Flood Risk Assessment - EA Objection – Ref NO/2023/115662/01-L01 - RESPONSE

We have reviewed the EA's letter of objection in relation to planning application 3/2023/0754. The EA give 4 reasons, each of which we have duplicated below, together with our response for consideration.

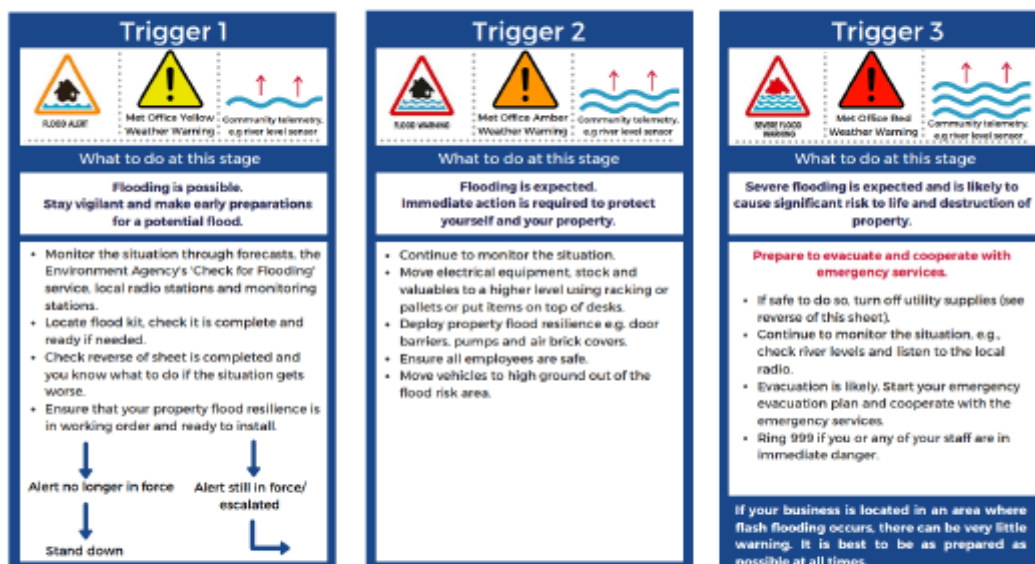
4. Consider the requirement for flood emergency planning including flood warning and evacuation of people for a range of flooding events up to and including the extreme event

Flood evacuation was considered in the submitted FRA and is reproduced below.

The existing business benefits from an established flood plan and is registered for advanced flood warnings with the Environment Agency. The evacuation plan is included as **Appendix D** for reference. It is recommended that this statement is updated to include specific reference to systematic procedures to address cars parked on the car park and members of staff / visitors on site.

The plan should provide clear instruction that sets out safe evacuation routes from the site and designated assembly locations as appropriate. The entrance to the site (and beyond) is located outwith an area at risk of flooding, so any such evacuation route could be easily defined given the route out of the business is in affect directly away from the source of flooding.

A typical 3 stage trigger plan is illustrated below. The proposed plan should aim to provide a similar systematic strategy.

The provision of a suitable updated flood evacuation plan would be drawn up in consultation with the LLFA and could, if necessary, be secured by condition.
